# PLAN COMMISSION STAFF REPORT

**Agenda Item:** PC Docket No. 23-002

**Application:** **Development Plan**

**Summary:** Fadi Layous requesting approval of a development plan for a medical office building at 500 45<sup>th</sup> Street.

1 LANDSCAPE PLAN  
1" = 20'-0"

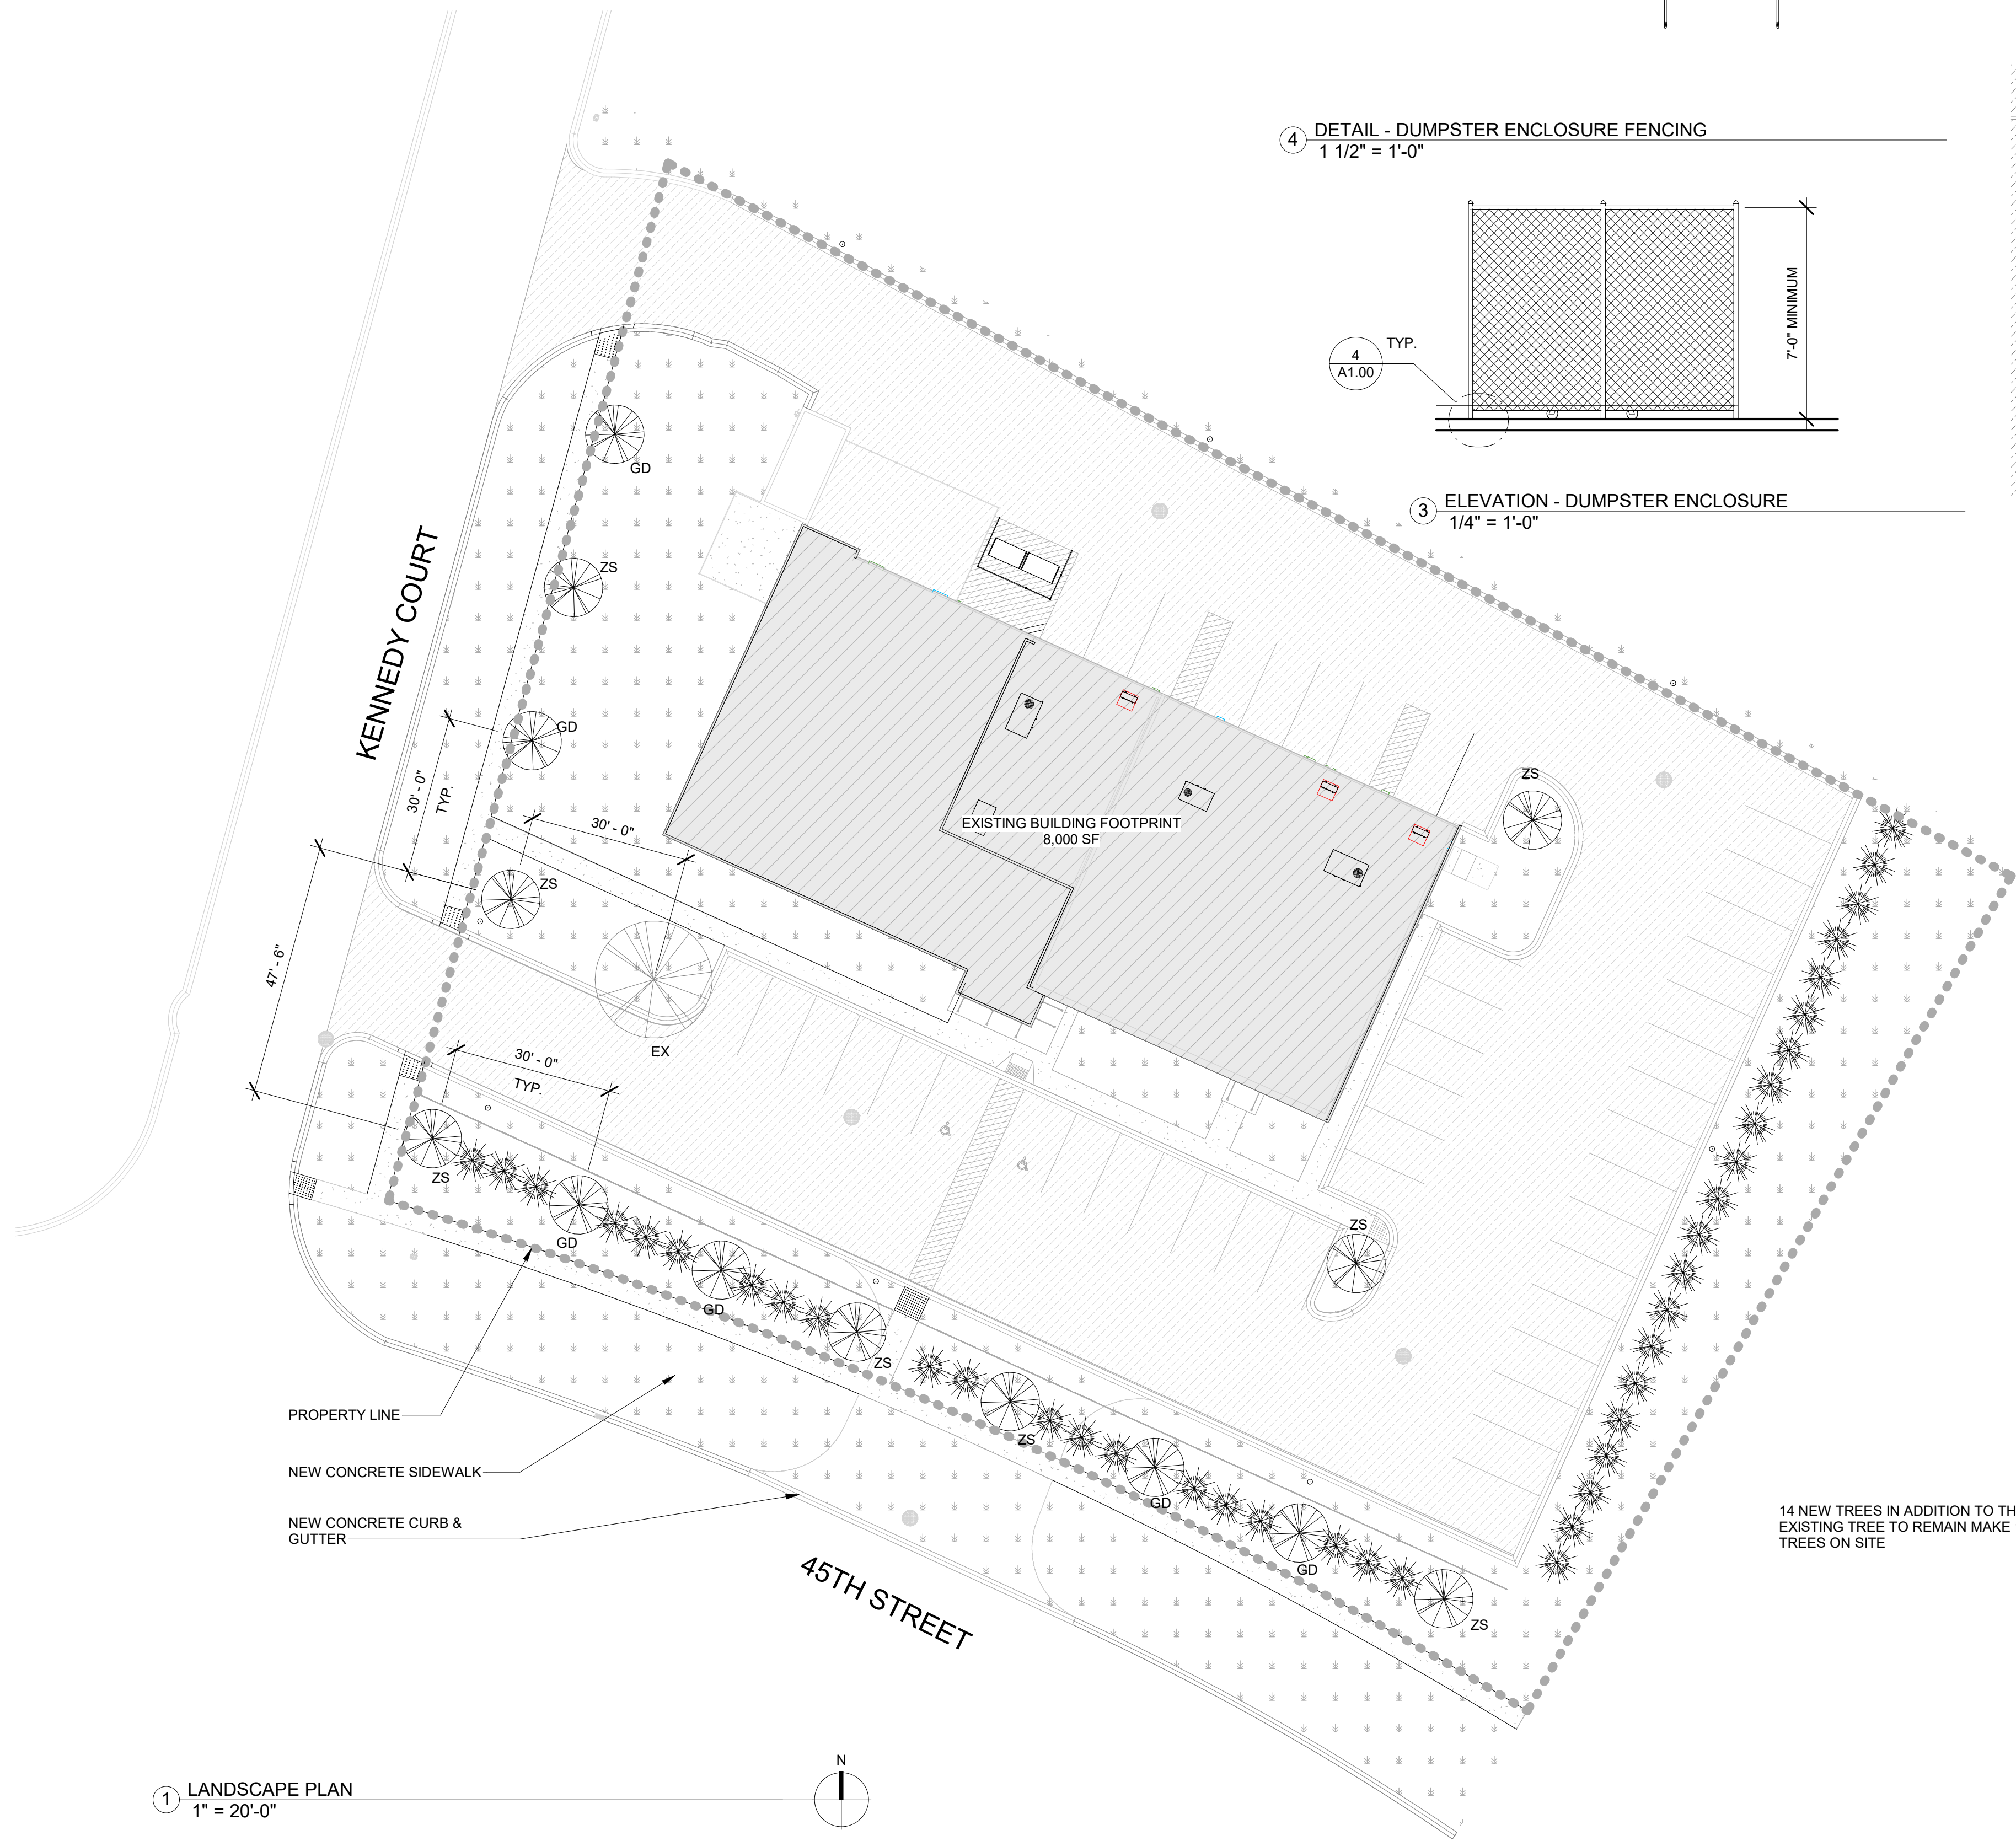
Staff notes that the plans must also show the installation of shade trees within the parkway (between the sidewalk and the street curb) 30' on center as well.

*Motion to approve PC Docket 23-002 granting approval of a development plan for a medical office building at 500 45<sup>th</sup> Street, upon the condition that the landscaping plan be revised to include the required street trees along 45<sup>th</sup> Street and Kennedy Court.*
